Agenda Date:	August 13, 2026	Application ID:	MSC 2025-0019
Project:	Applebee's Pembroke Pines	Project Number:	N/A
Project Planner:	Julia Aldridge, Associate Planner		
Owner:	LSG1 Pembroke Place LLC %Longpoint Realty Partners LLP	Agent:	Rachael Cooper
Location:	10135 Pines Boulevard	Commission District:	2
Existing Zoning:	General Business (B-3)	Existing Land Use:	Commercial
Reference Applications:	SP 93-43, MSC 2012-12		
Applicant Request:	Exterior modifications to an existing building.		
Staff Recommendation:	Approval		
Final:	☒ Planning & Zoning Board	☐ City Commission	
Reviewed for the Agenda:	Director:  Assistant Director:

Rachael Cooper, agent, is requesting approval for exterior color, façade and signage modifications to the existing restaurant, Applebee's, generally located north of Pines Boulevard and west of Palm Avenue.

Date: July 8, 2025
To: MSC 2025-0019
From: Julia Aldridge, Planner / Zoning Technician
Re: Applebee's @ 10135 Pines Boulevard

1 EXTERIOR ELEVATION - FRONT - SOUTH
1/4" = 1'-0"

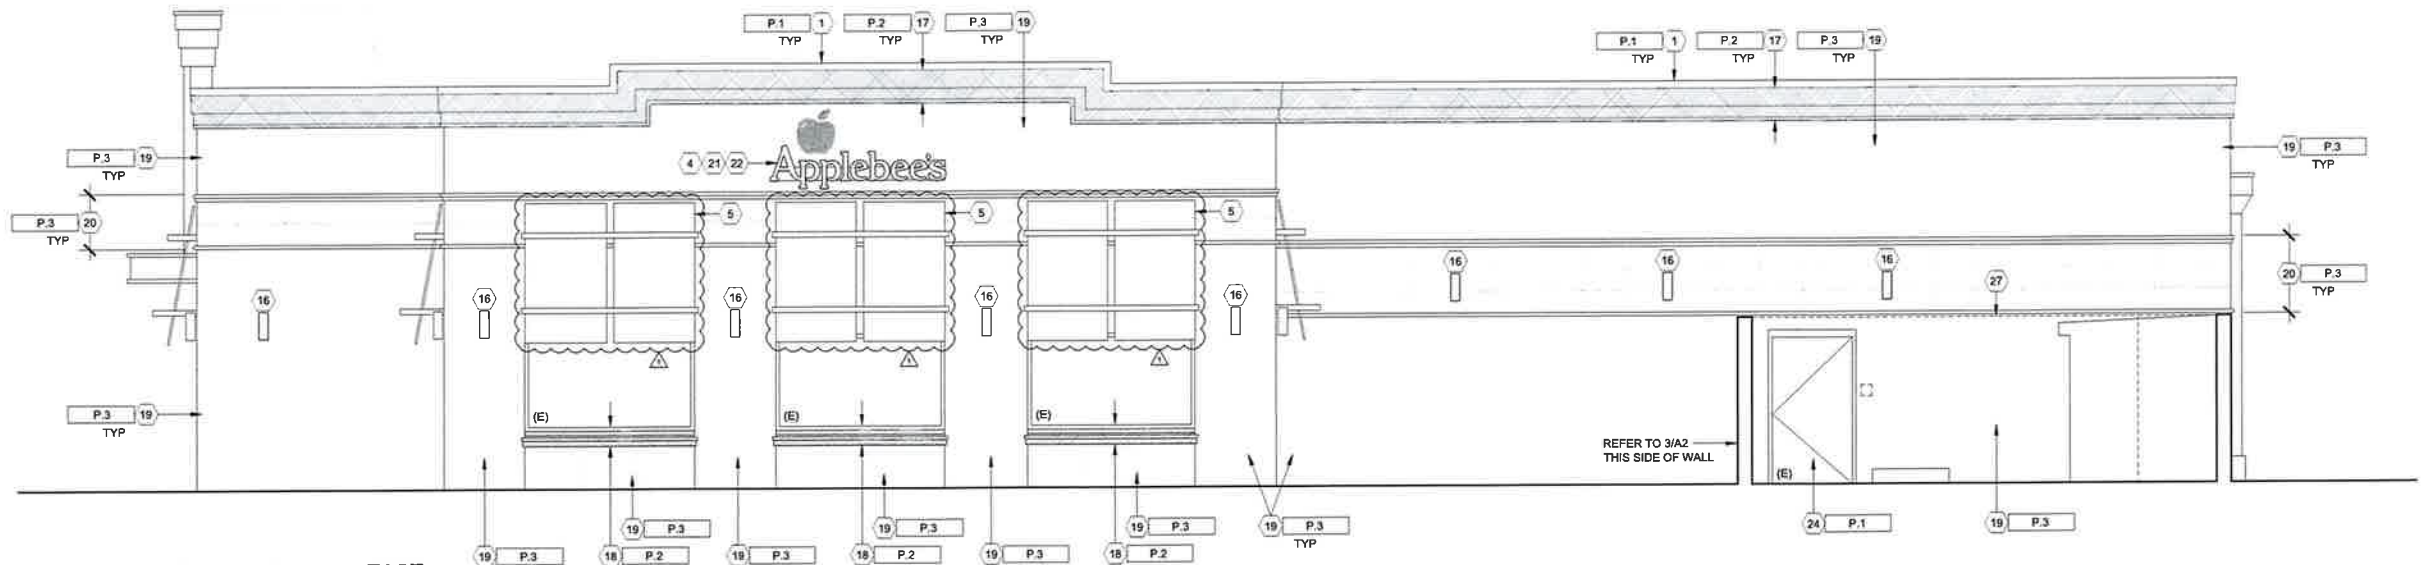
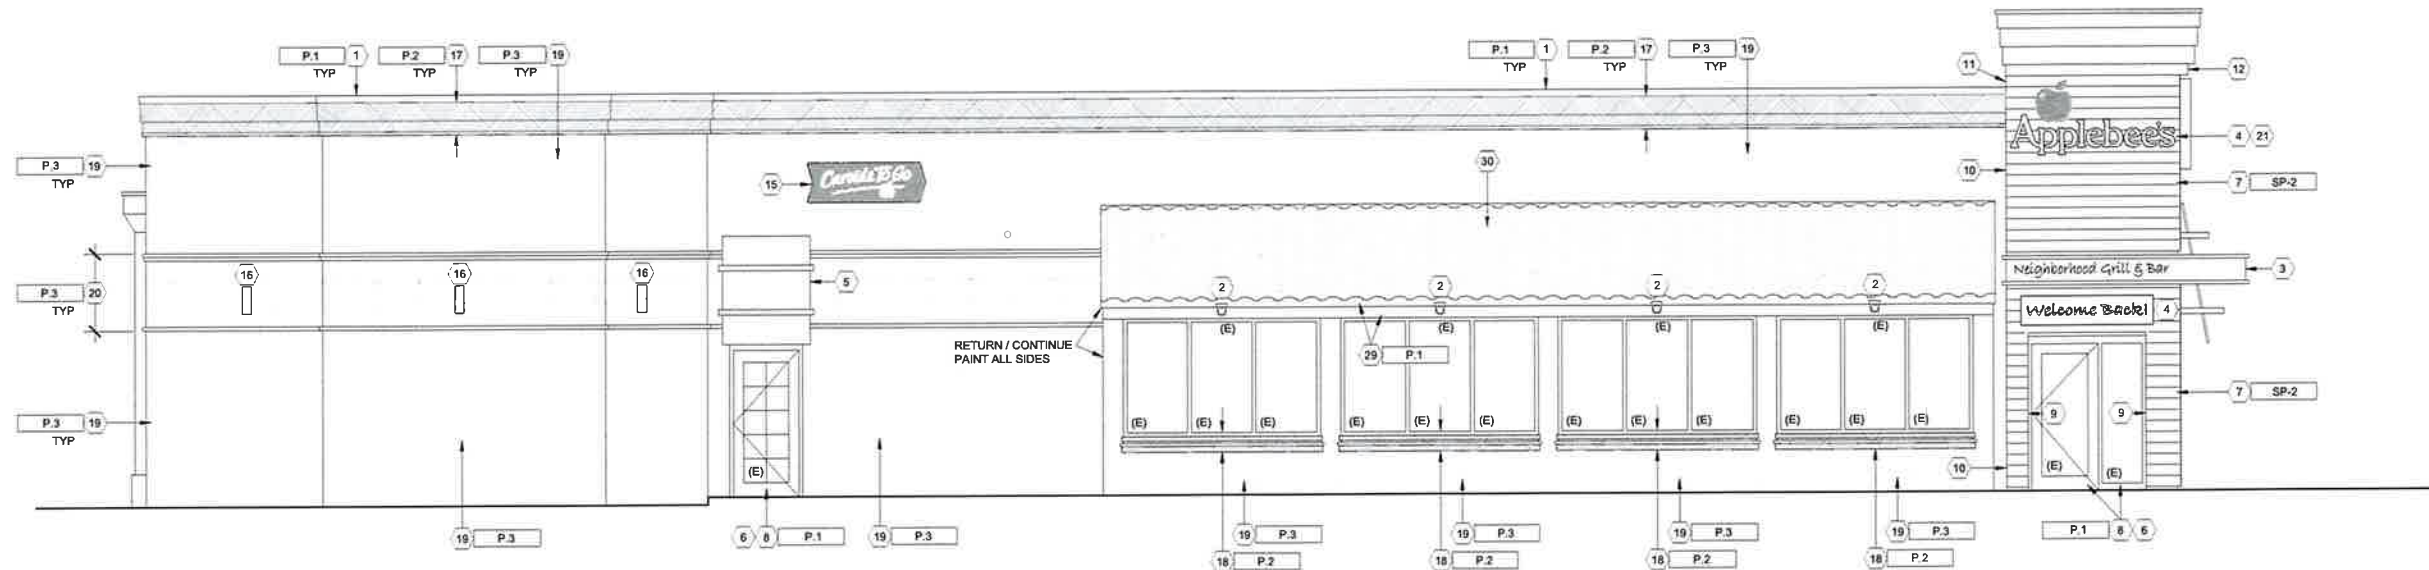
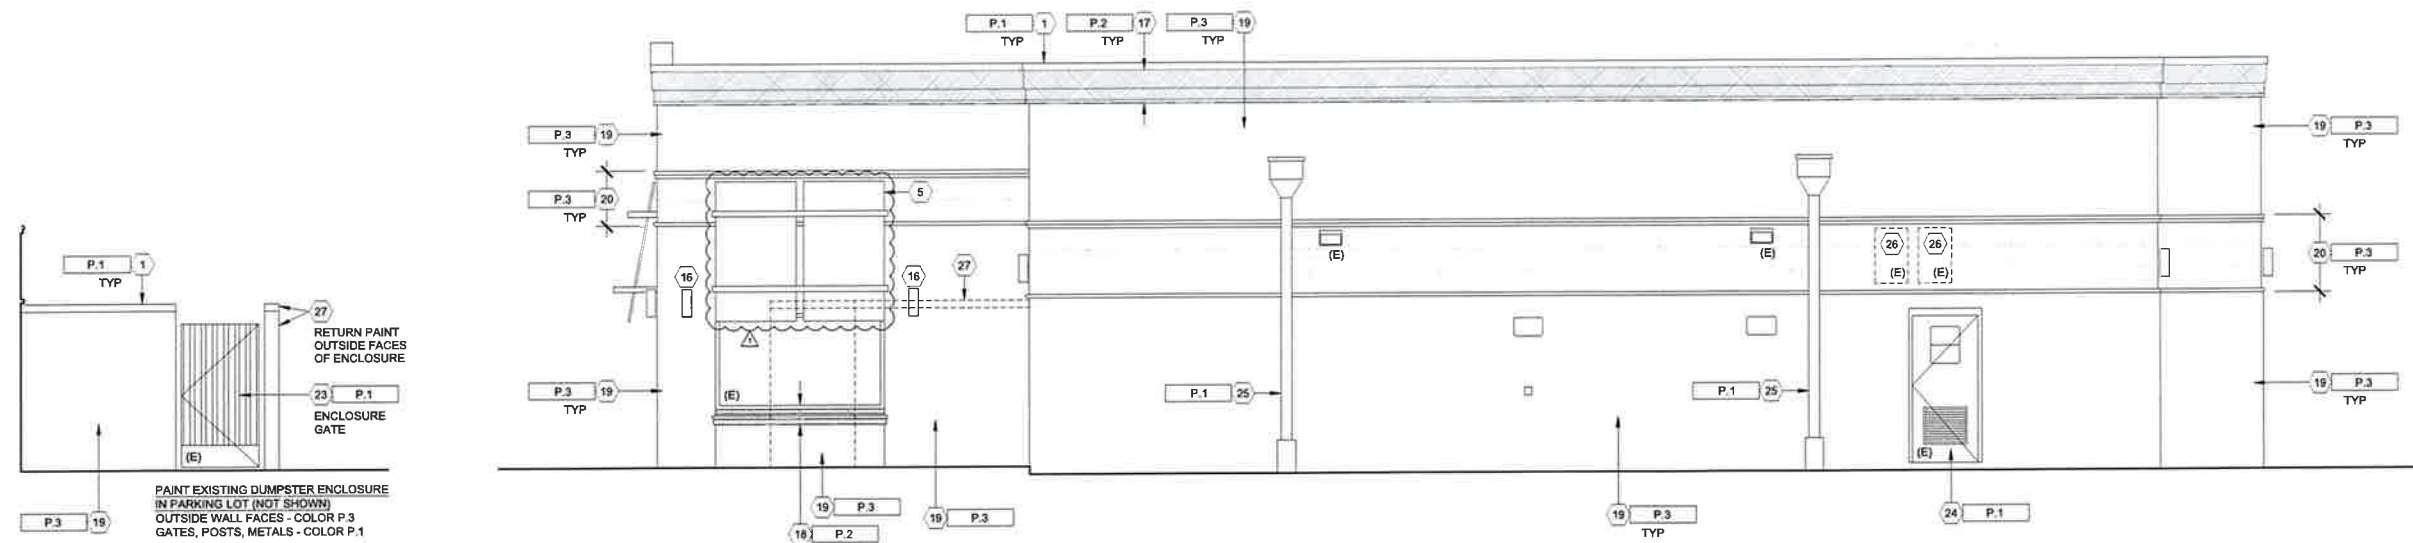
4. Provide renderings for proposed paint colors consistent with elevations provided. Label all paint colors on renderings. Include renderings of dumpster enclosure and monument sign. 10/27/25- Not provided. Sheets A1 and A2 show paint details. Renderings with proposed paint colors are required. 3/31/26- Not provided. **7/21/2026- Dumpster enclosure must be painted to match building. Renderings do not include dumpster. Please ensure sets of plans are consistent.**

AWNING BLADE DETAIL
SCALE: 1/4" = 1'-0"

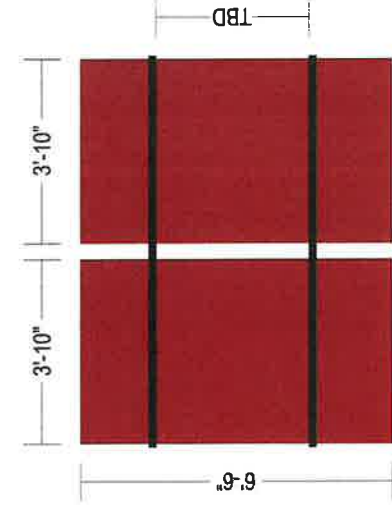
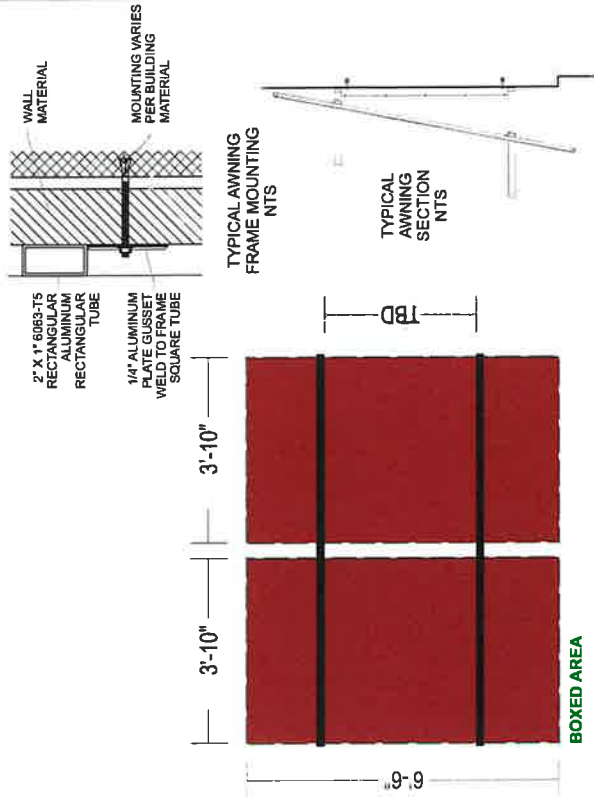
2. Clarify if any signage being proposed on the awnings? Elevations and renderings are inconsistent. **10/27/25- Not provided. Awnings on "architectural plan" are not consistent with awnings on "permit set" showing logo. Awning signage will be counted towards the maximum of 120 SF. 3/31/26- Some notes on the plans are still specifying awnings with logo. Please clarify.**

2. Clarify if any signage being proposed on the awnings? Elevations and renderings are inconsistent. 10/27/25- Not provided. Awnings on "architectural plan" are not consistent with awnings on "permit set" showing logo. Awning signage will be counted towards the maximum of 120 SF. **3/31/26- Some notes on the plans are still specifying awnings with logo. Please clarify.**

EXISTING AWNING FRAME WILL REMAIN IN PLACE
6'-6" X 3'-10" AWNING BLADES WITHOUT LOGO

PROPOSED:
.080 alum painted PMS 187C Red
